**Dye Branch II
Stream Restoration
MY8 Monitoring Report (2019)
NCDMS Project Number: 92255**

**Submitted to
North Carolina Division of Mitigation Services
North Carolina Department of Environmental Quality
March 2020**

Re: Monitoring Year 8 Draft Report for the
Dye Branch II Stream Restoration Site
Yadkin River Basin – CU# 03040105–Iredell County
EEP Project ID No. 92255
Monitoring Contract # 004523

I have outlined our responses to the comments on the Draft Monitoring Year 8 report for the Dye Branch II Stream Restoration Site in (Red).

Figure 2. Integrated Current Condition Plan View

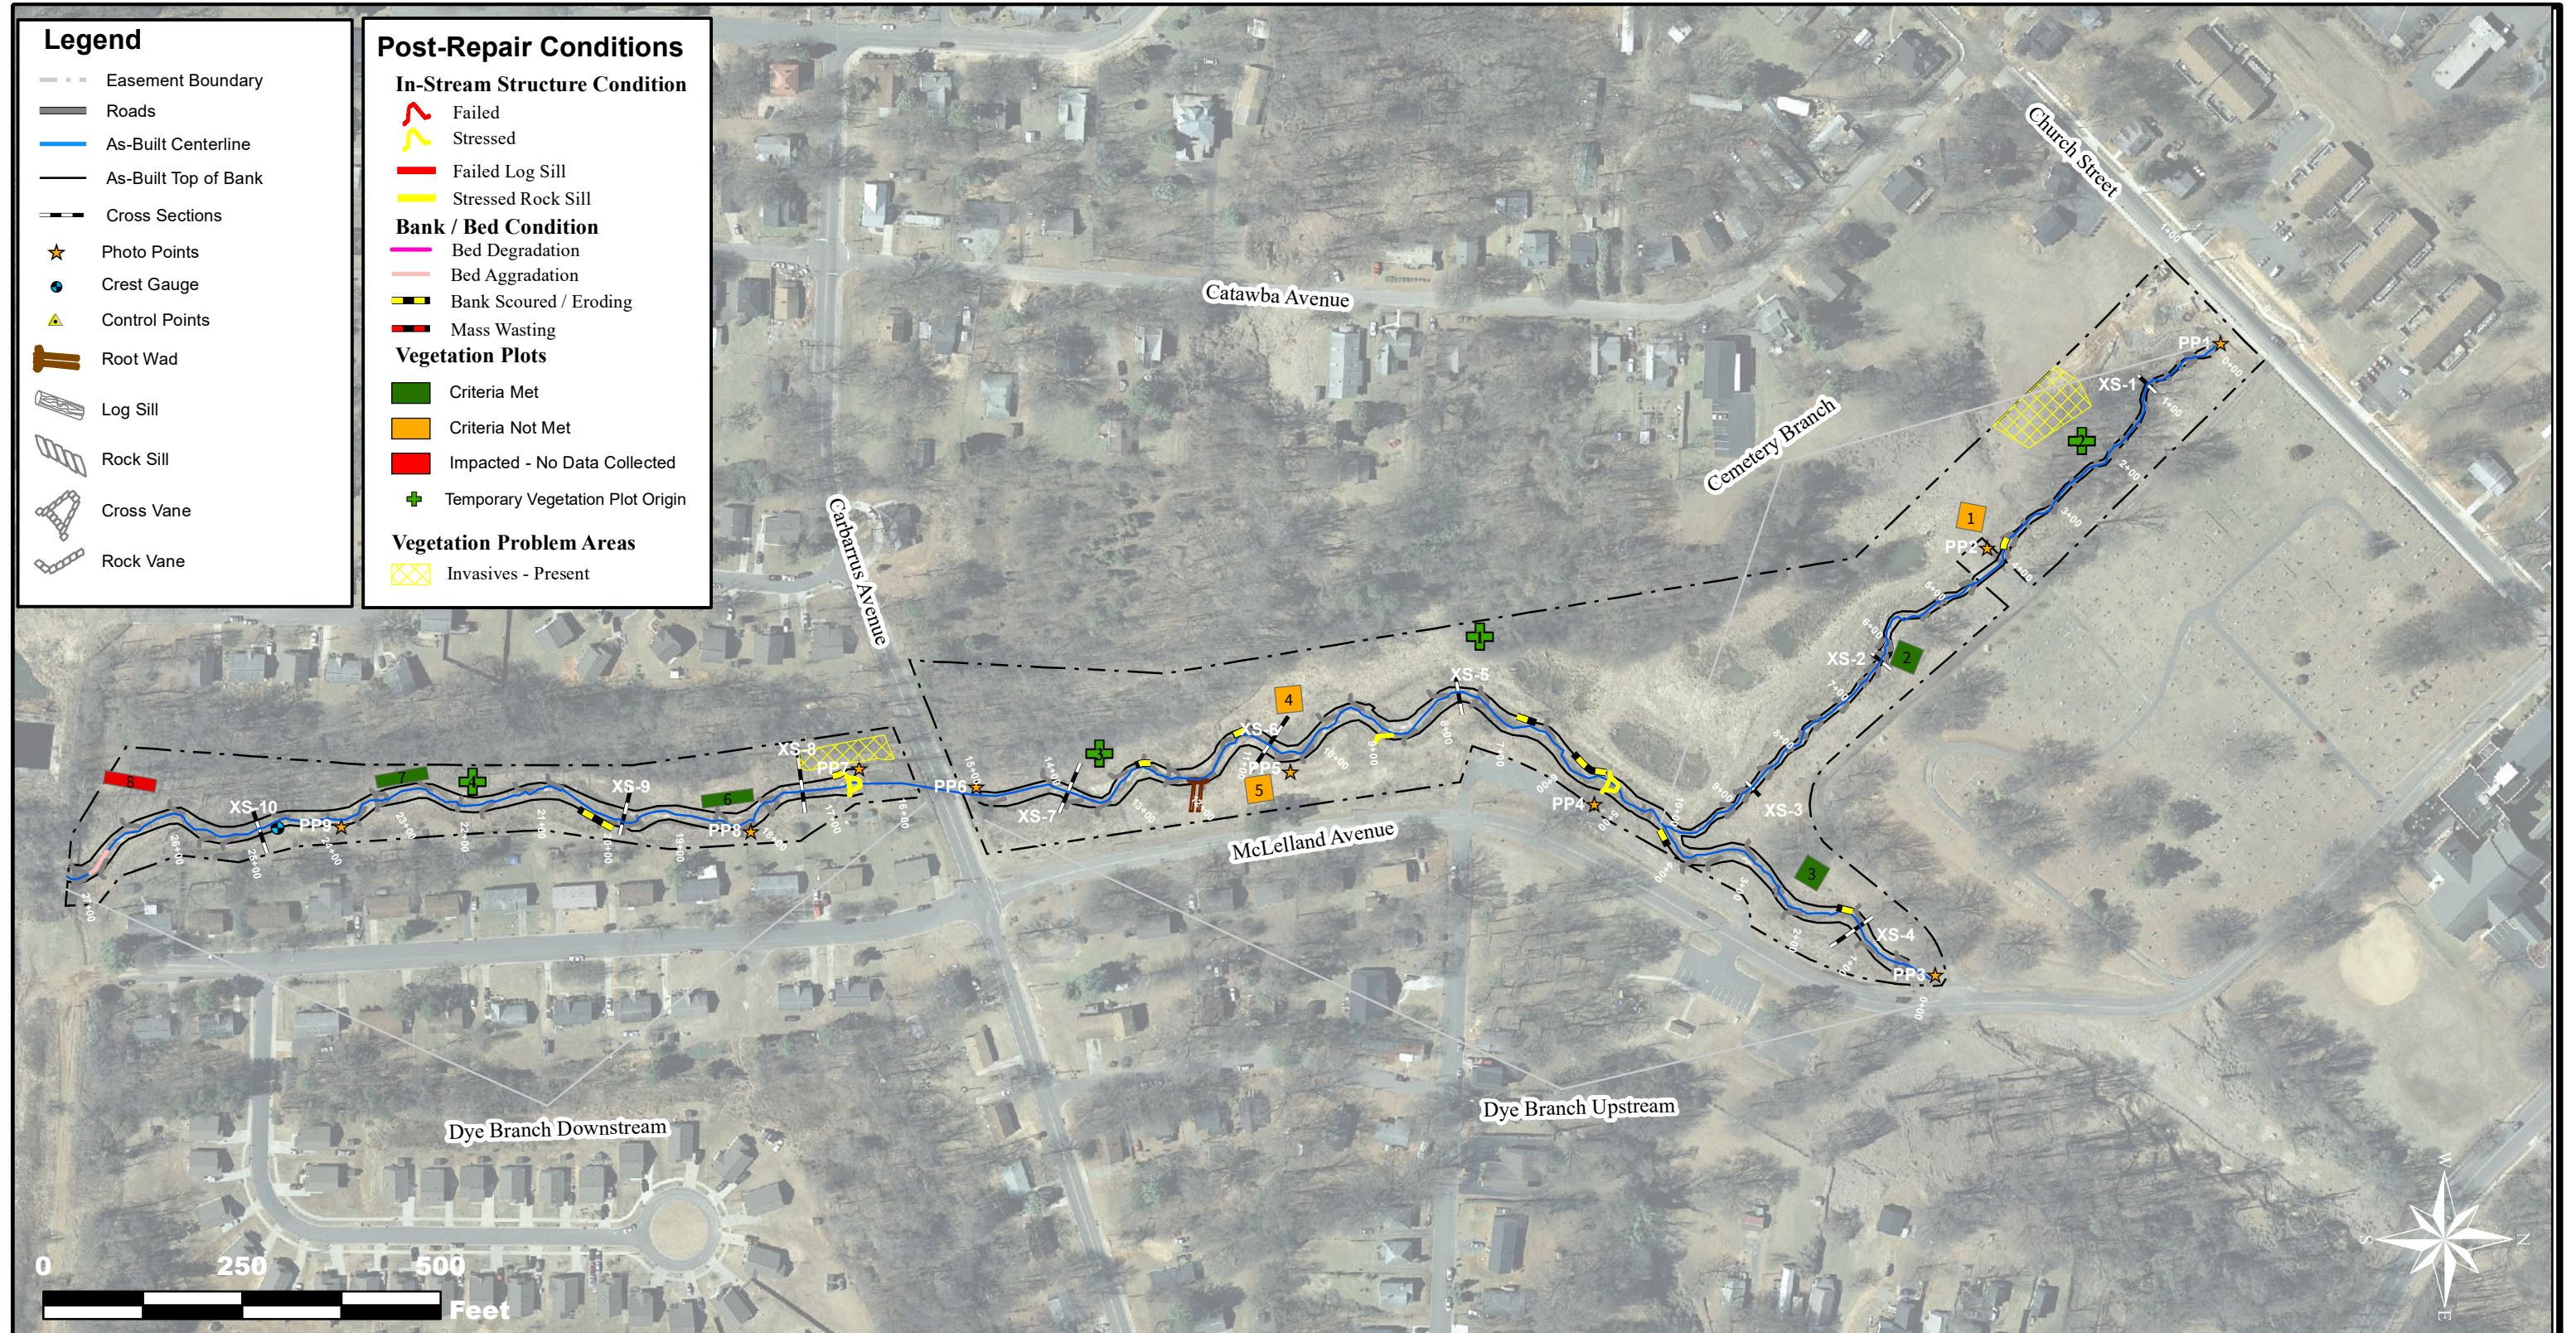
- The CCPV invasive polygon has not been updated since MY5. A contractor has spent a considerable amount of time on the site treating invasives to meet a threshold that will be acceptable for regulatory closure. While there may still be some invasives present, this polygon does not represent the current site conditions based on DMS site inspections of the contractor's work. DMS will continue treating the site through regulatory close out. Please update the invasive polygon to reflect current site conditions. **CCPV updated to reflect MY8 treatments.**
